Proposal for MPR and metric of HD-EV

China, April 16, 2024

MPR Evaluation: M3<7.5t

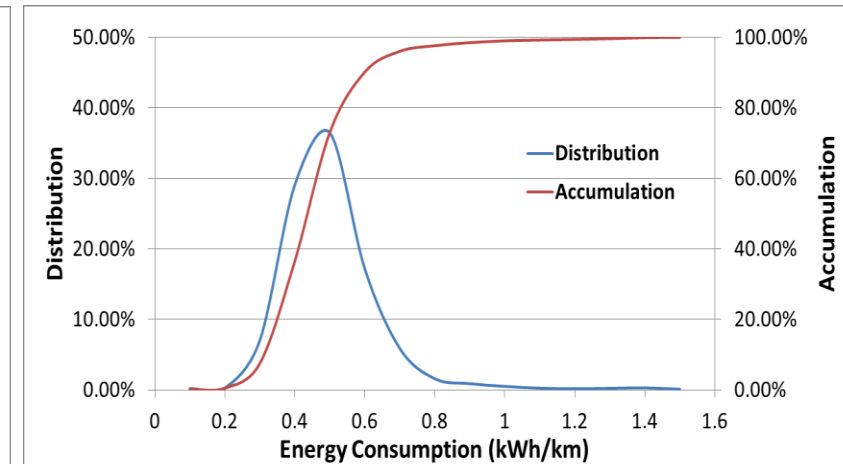
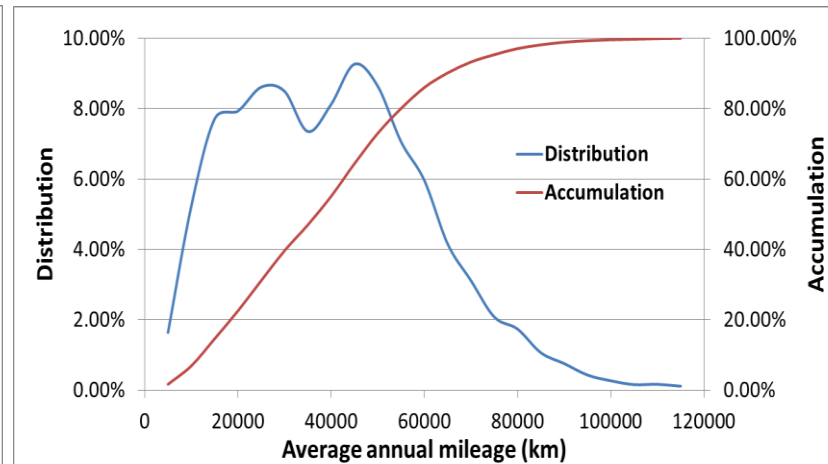
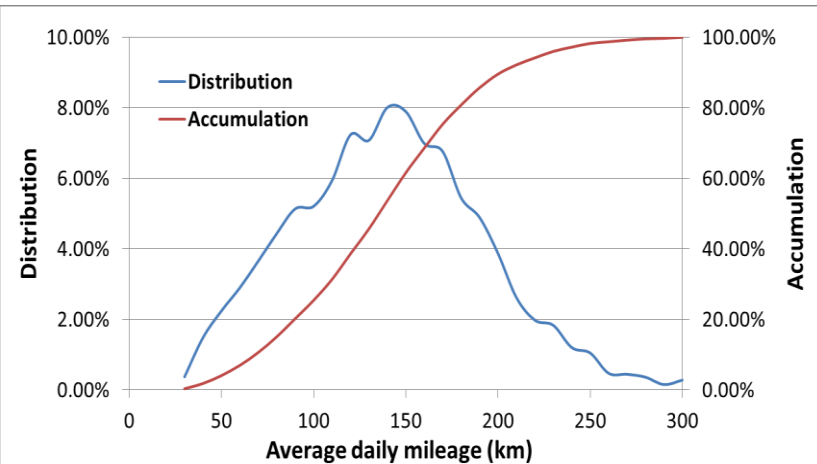
- ✓ The average daily mileage of M3<7.5t type HD-EVs is concentrated in the 100-200km range, and about 90% vehicles within the 0-200km range.
- ✓ The year mileage of M3<7.5t type HD-EVs is concentrated in the 20000-60000km range, and about 90% vehicles within the 0-65000km range.
- ✓ The energy consumption of M3<7.5t type HD-EVs is concentrated in the 0.4-0.6kWh/km range, which is a narrow contribution, meas highly similar operation scenario for M3<7.5t type HD-EVs.

- ✓ The 300,000km of lifetime in draft is not enough for M3<7.5t type HD-EVs, which corresponding to 37,500km per year for 8 years lifetime, only meet 50% vehicles operation requirement.
- ✓ The battery cyclic performance and energy consumption of M3<7.5t type HD-EVs can support 500,000km lifetime, which corresponding to 62,500km per year for 8 years lifetime, meet 90% vehicles operation requirement.

M3<7.5t	HD-PEV	HD-OVC-HEV
Main Lifetime [500,000] km or [8] years, whichever comes first	70%	70%

MPR Evaluation: M3>7.5t

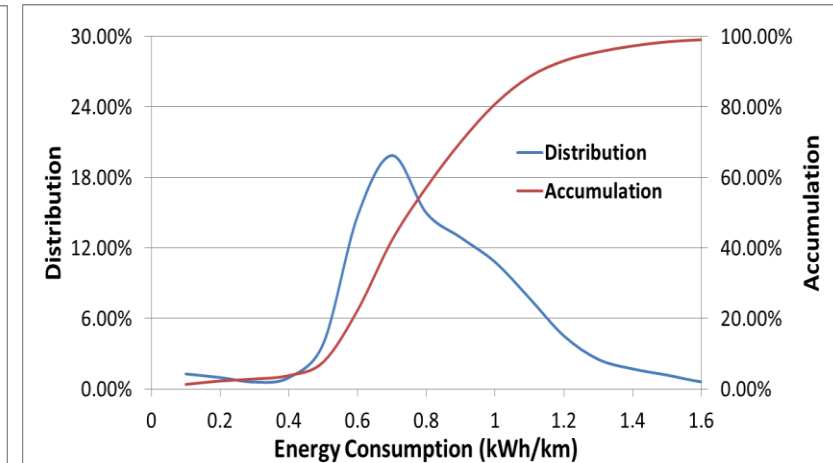
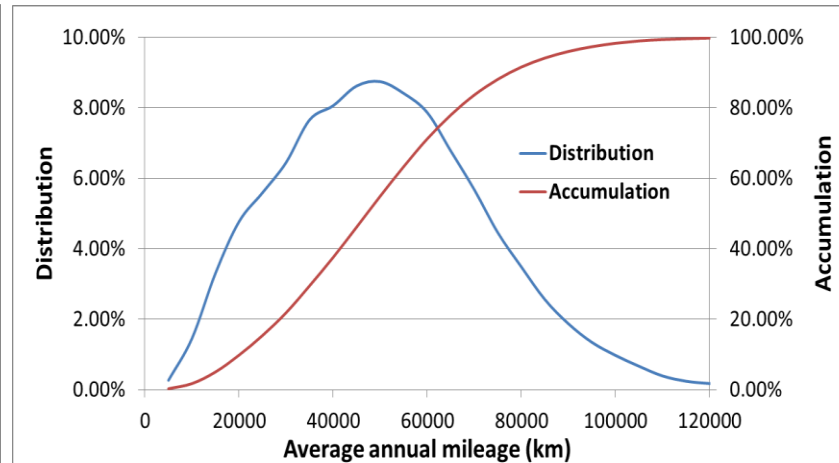
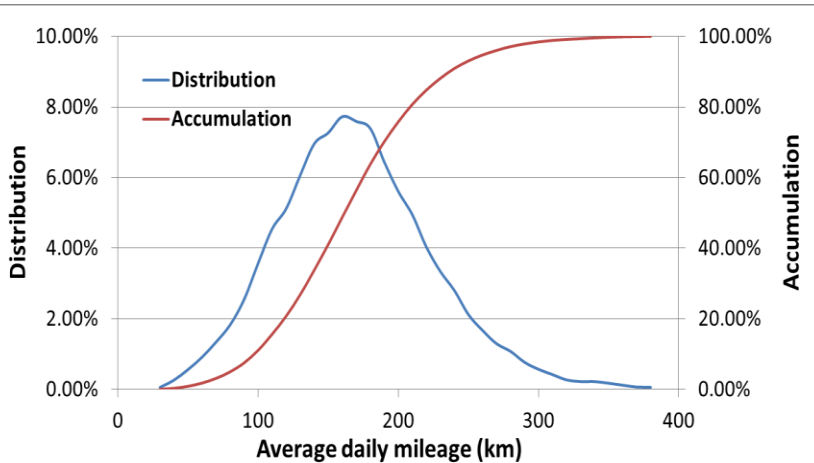
- ✓ The mileage and energy range of M3>7.5t type HD-EVs are quietly similar with M3<7.5t.
- ✓ The average daily mileage and year mileage distribution of M3>7.5t type HD-EVs are wider than M3<7.5t.
- ✓ About 90% vehicles within the 0-240km average daily mileage range and 0-75000km year mileage range.
- ✓ The energy consumption of M3>7.5t type HD-EVs is concentrated in the 0.6-1.0kWh/km range, which is a relatively narrow contribution.

- ✓ The battery cyclic performance and energy consumption of M3>7.5t type HD-EVs can only support 600,000km lifetime, which corresponding to 75,000km per year for 8 years lifetime, meet 90% vehicles operation requirement.

M3>7.5t	HD-PEV	HD-OVC-HEV
Main Lifetime [600,000] km or [8] years, whichever comes first	70%	70%

MPR Evaluation: N2,N3<16t

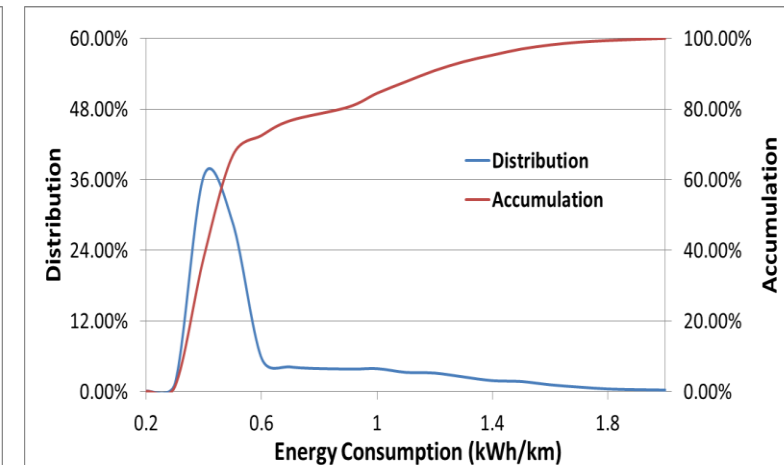
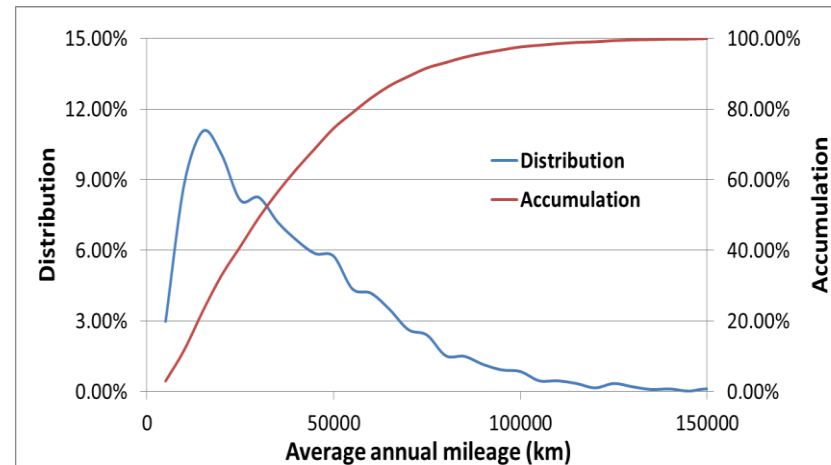
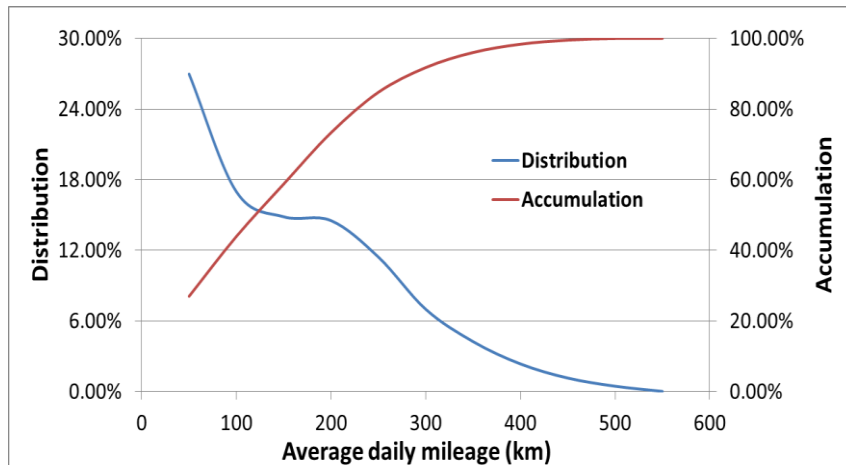
- ✓ The average daily mileage of N2,N3<16t type HD-EVs is concentrated in the 100-300km range, and about 90% vehicles within the 0-320km range.
- ✓ The year mileage of N2,N3<16t type HD-EVs is concentrated in the 20000-60000km range, and about 90% vehicles within the 0-80000km range.
- ✓ The energy consumption of N2,N3<16t type HD-EVs is concentrated in the 0.4-0.5kWh/km range, but with a wide contribution at the 0.6-1.8kWh/km range, meas various operation scenario for N2,N3<16t type HD-EVs.

- ✓ The 300,000km of lifetime in draft is not enough for N2,N3<16t type HD-EVs, which corresponding to 37,500km per year for 8 years lifetime, only meet 40% vehicles operation requirement.
- ✓ The battery cyclic performance and energy consumption of N2,N3<16t type HD-EVs can support 400,000km lifetime, which corresponding to 50,000km per year for 8 years lifetime, meet 75% vehicles operation requirement.
- ✓ Considering the various operation scenario (such as sanitation truck and transport truck) and energy consumption, the energy throughput shall added, which is $2800 * UBE_{certified}$ corresponding to battery cyclic performance.

N2,N3<16t	HD-PEV	HD-OVC-HEV
Main Lifetime [400,000] km or [8] years or $2800 * UBE_{certified}$, whichever comes first	70%	70%

MPR Evaluation: N3>16t

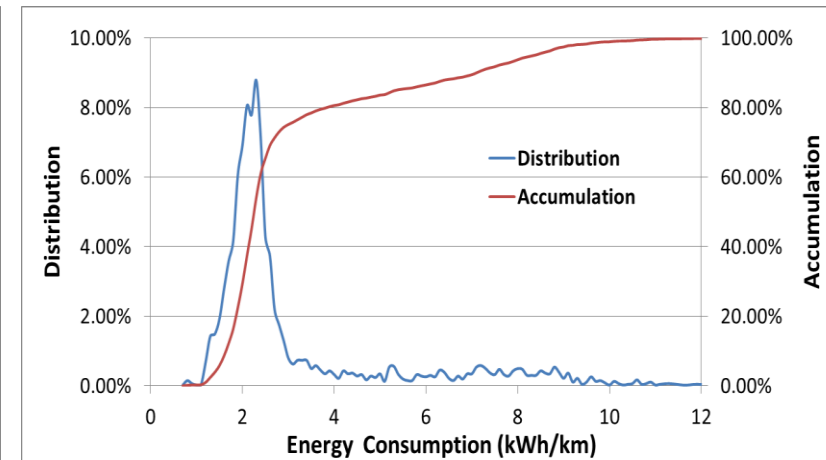
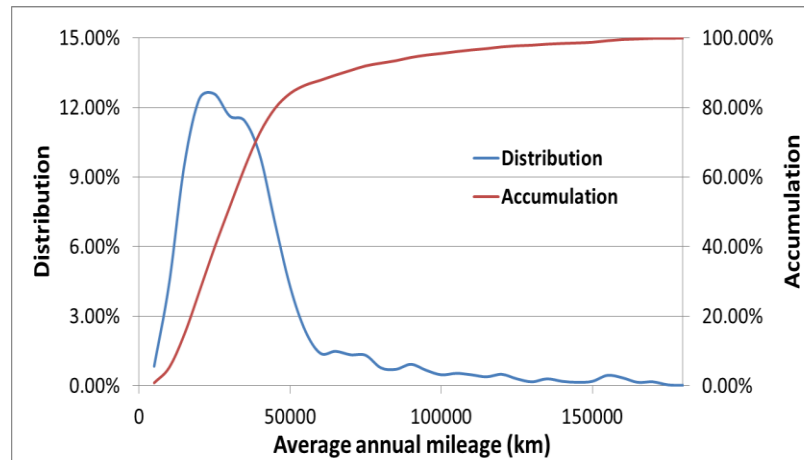
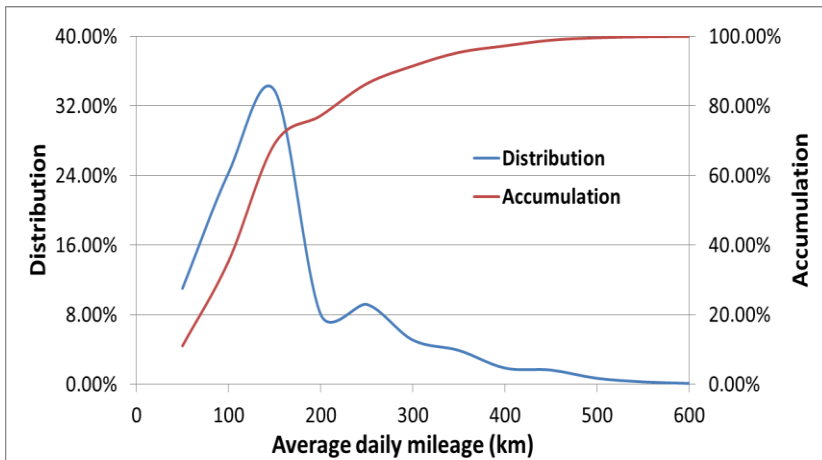
- ✓ The mileage and energy consumption distribution of N3>16t type HD-EVs are much wider than N2,N3<16t.
- ✓ The average daily mileage of N3>16t type HD-EVs has a narrow distribution at range of 0-200km and a wide distribution at range of 200-400km, and about 90% vehicles within the 0-300km range.
- ✓ The average daily mileage of N3>16t type HD-EVs has a narrow distribution at range of 20,000-40,000km and a wide distribution at range of 40,000-70,000km, and about 90% vehicles within the 0-70,000km range.
- ✓ The energy consumption of N3>16t type HD-EVs HD-EVs has a narrow distribution at range of 1.5-3.0kWh/km and a extremely wide contribution at range of 3.0-9.0kWh/km, meas complicated operation scenario for N3>16t type HD-EVs.

- ✓ The battery cyclic performance and power consumption of N3>16t type HD-EVs can only support 600,000km lifetime, which corresponding to 75,000km per year for 8 years lifetime, meet 92% vehicles operation requirement.
- ✓ Considering the extremely high energy consumption, the energy throughput shall added, which is $2800 * UBE_{certified}$ corresponding to battery cyclic performance.

N3>16t	HD-PEV	HD-OVC-HEV
Main Lifetime [600,000] km or [8] years or $2800 * UBE_{certified}$, whichever comes first	70%	70%
